**MEETING OF THE
PLANNING AND ZONING BOARD
QUASI-JUDICIAL PUBLIC HEARING**

February 21, 2017

**TOWN OF BAY HARBOR ISLANDS
COMMUNITY DEVELOPMENT
MEMORANDUM**

Subject: Site Development Plan Application
 30 DU Multi-Family Residential Complex
 9880-9900 W. Bay Harbor Drive
 Bay Harbor Islands Acct. No. MB2016-142
 MMPA Acct. No. 01-0702-1044

PROPOSED DESIGN

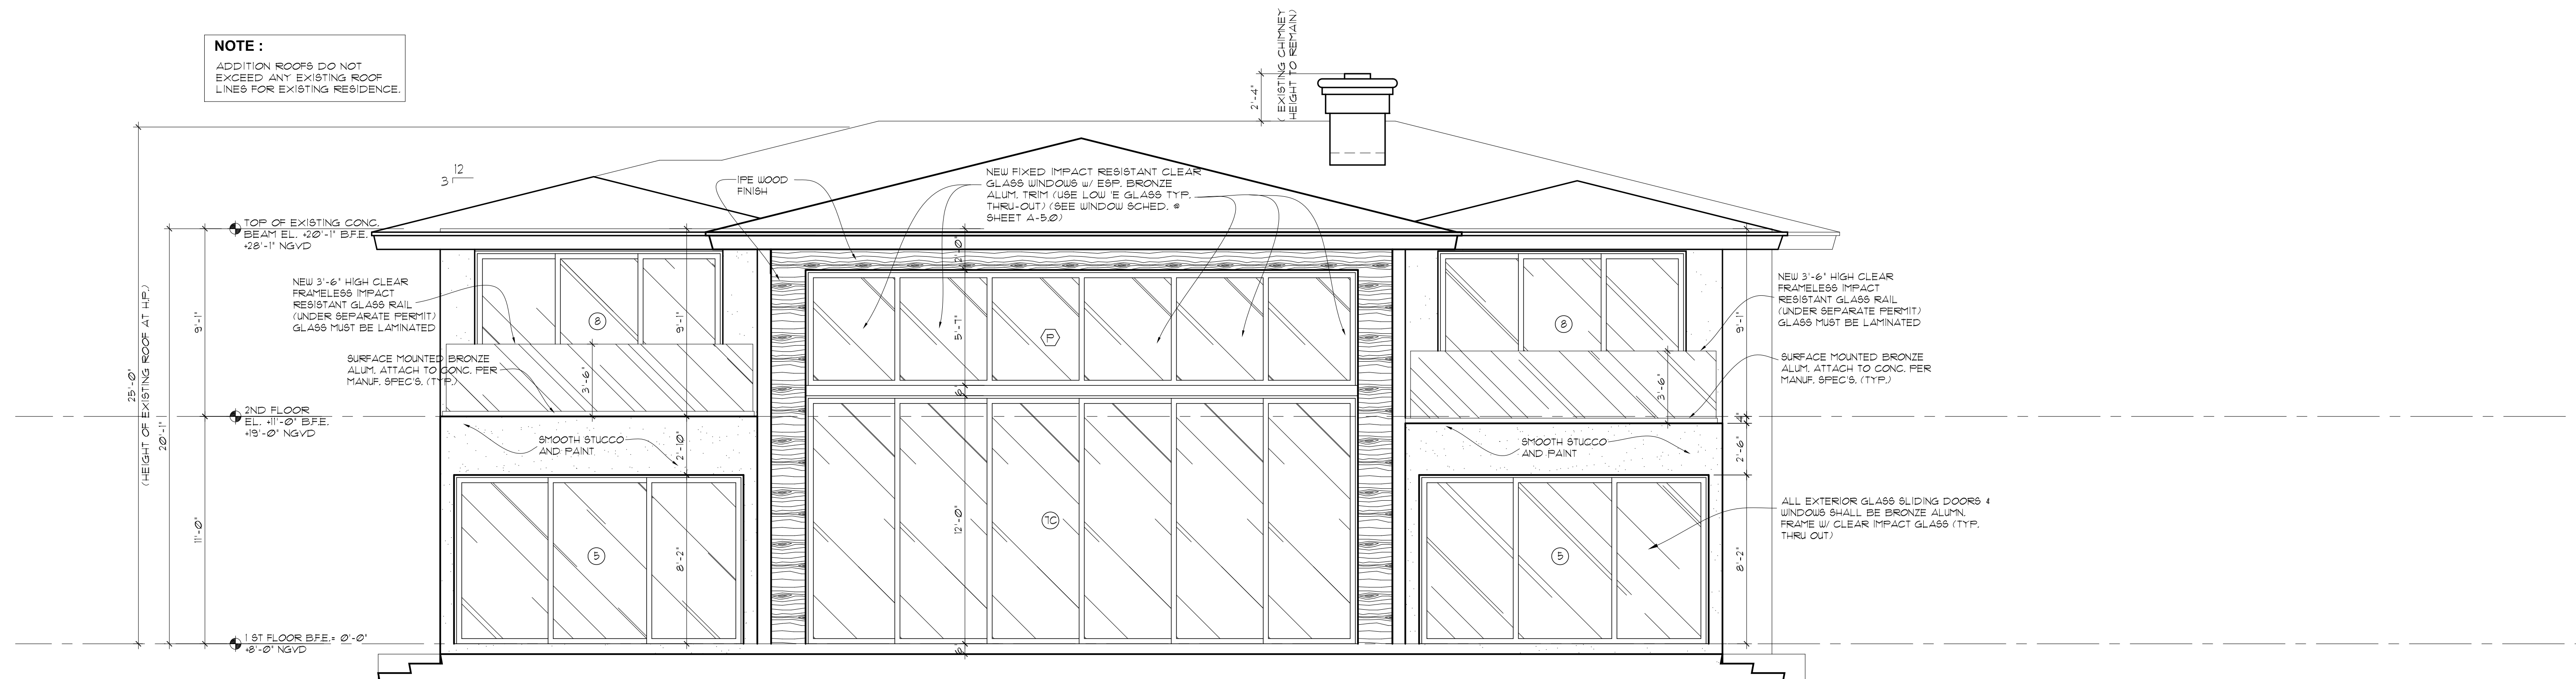
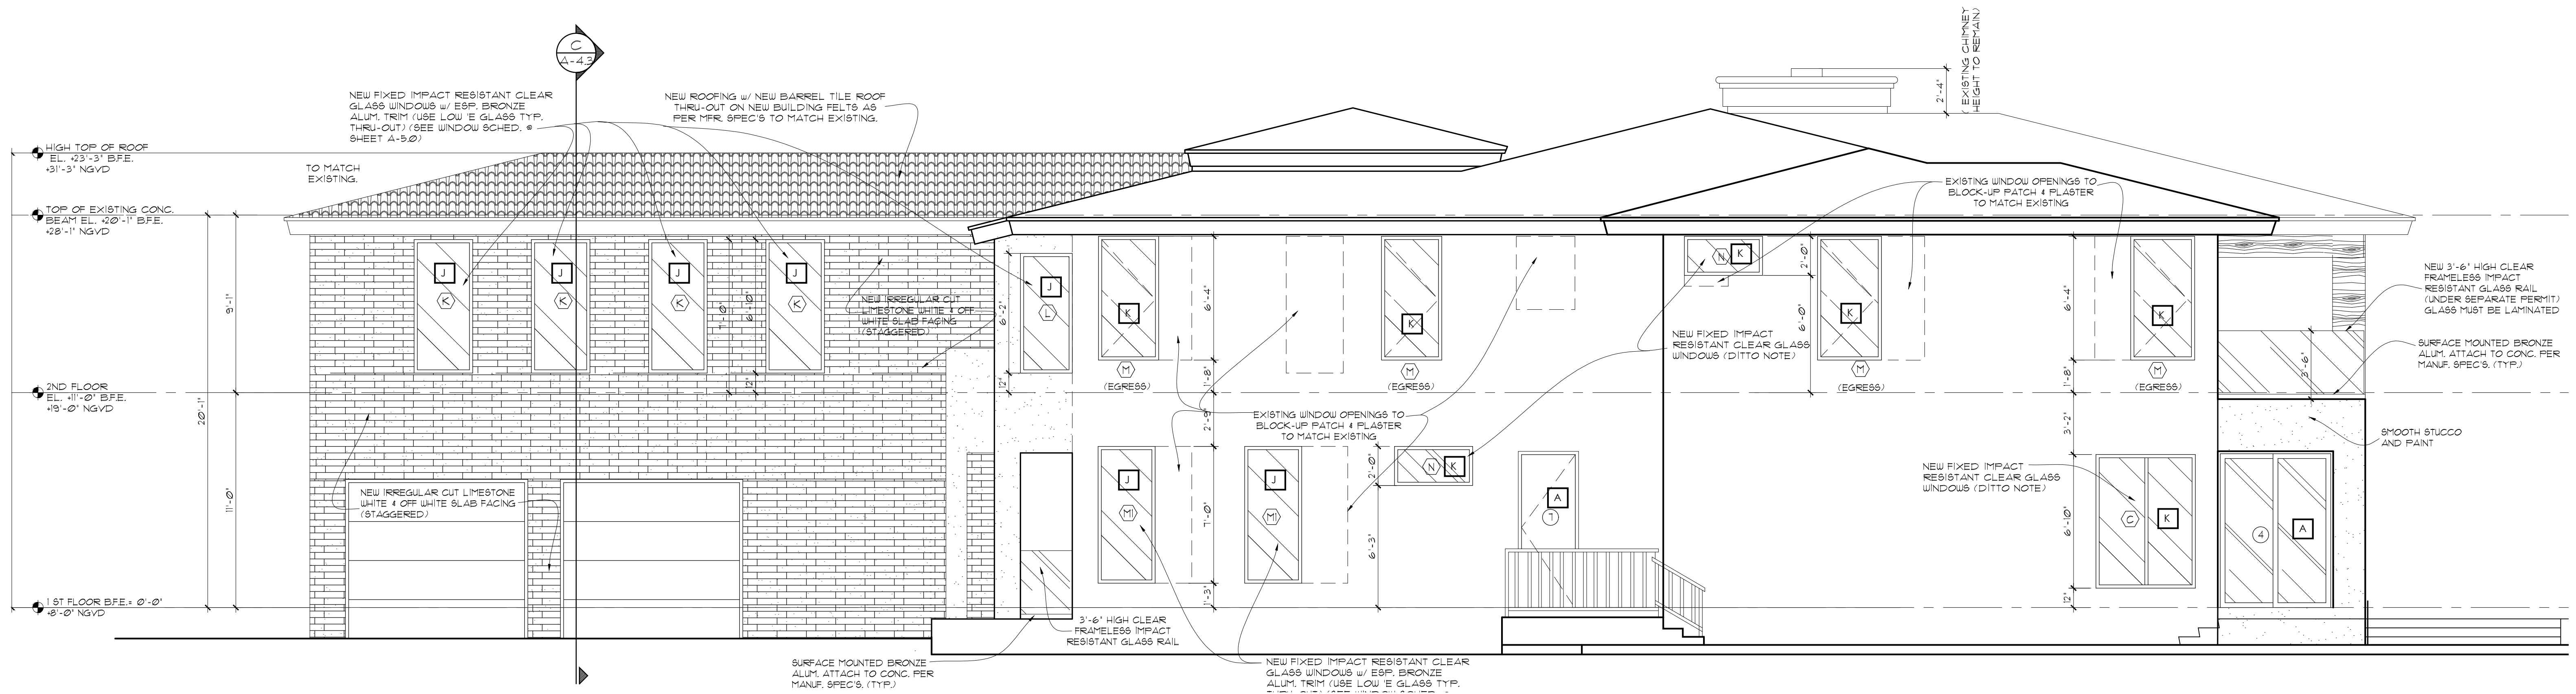
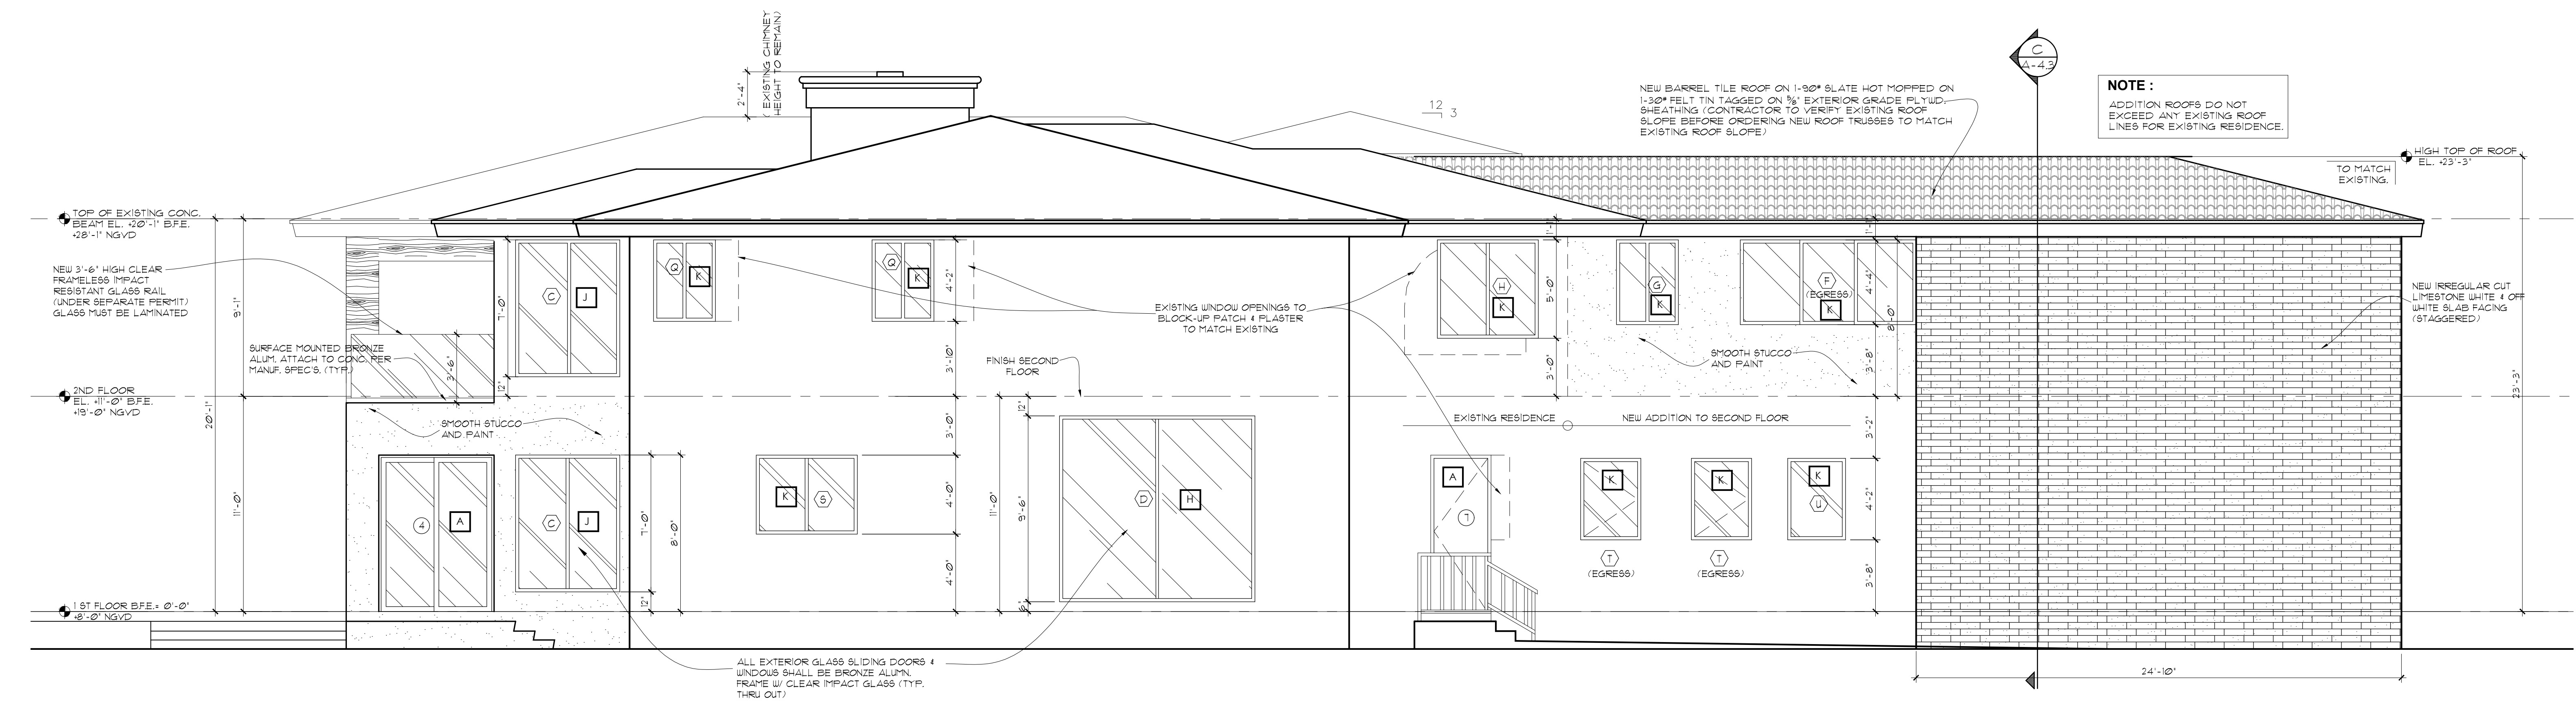
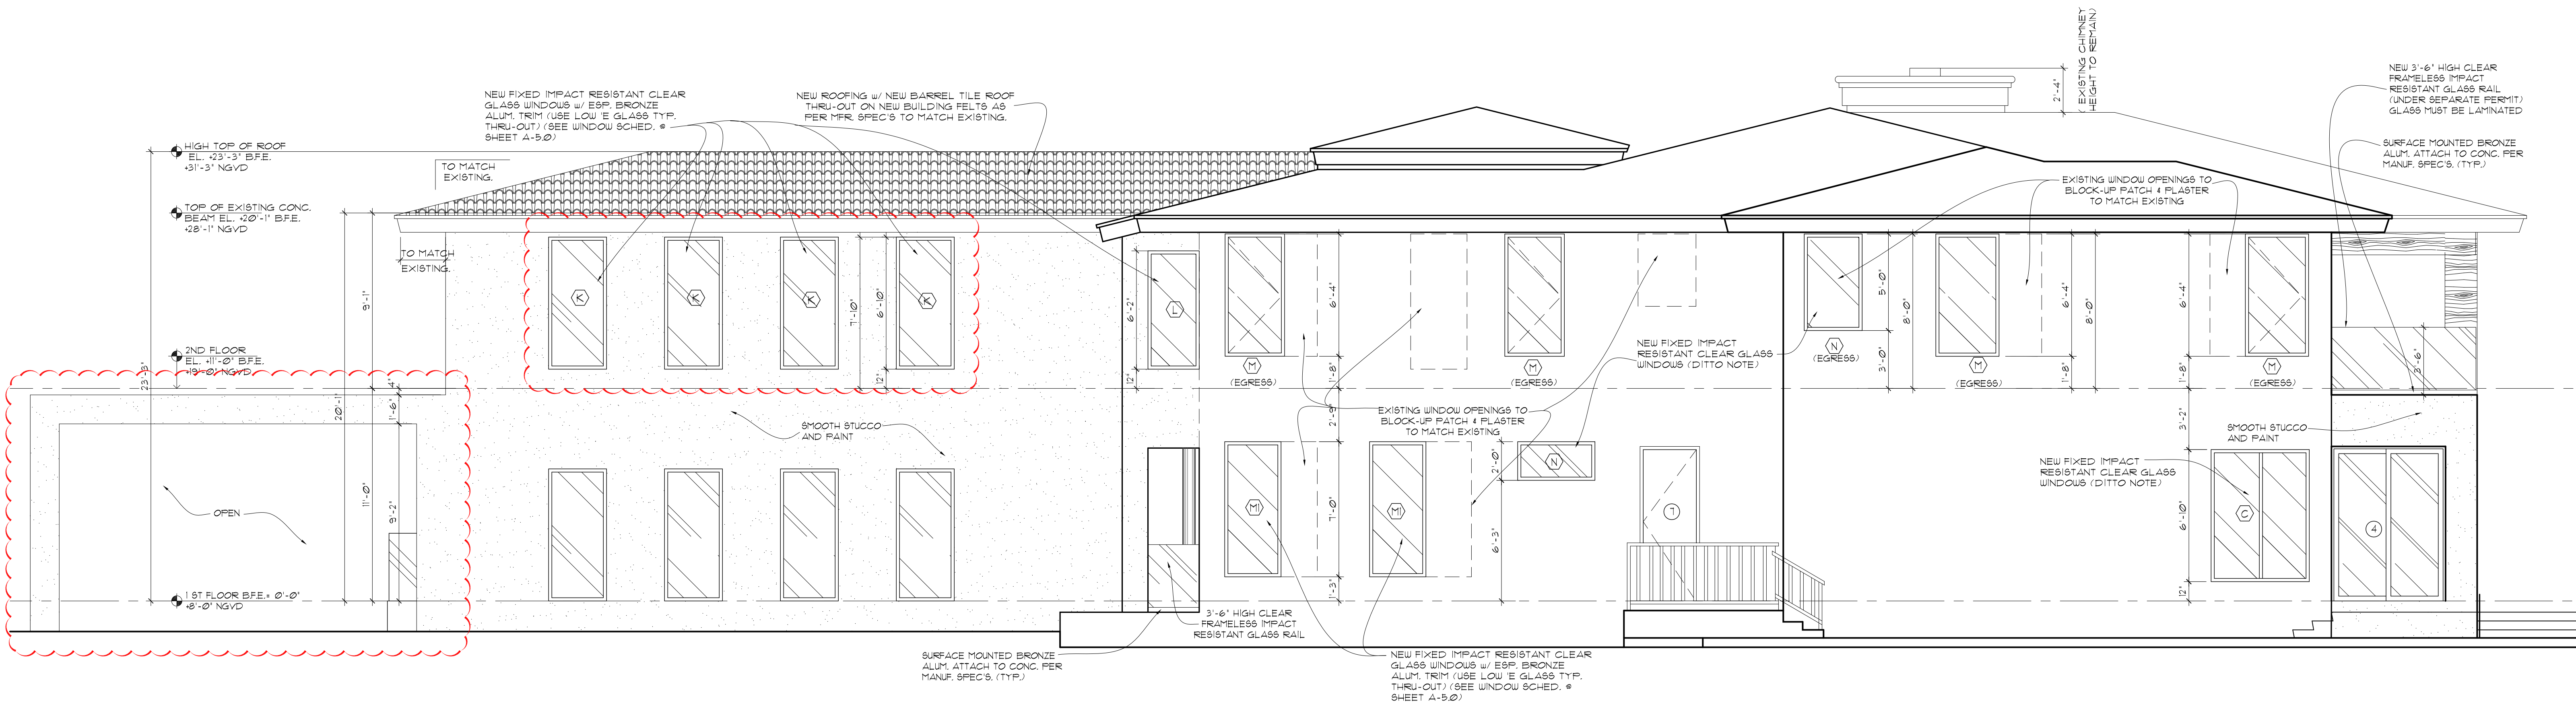
- 1) The applicant is now proposing to enclose the existing two-car garage for a "future interior space". The garage doors will be filled in and windows added. The previously approved stone material is also proposed to be replaced with smooth stucco. **PZB approval is requested for the proposed change.**
- 2) The applicant is proposing to modify the previously approved front entry design. The proposed design will be a thin roof overhang rather than the previously approved walkthrough structure. **PZB approval is requested for the proposed change.**
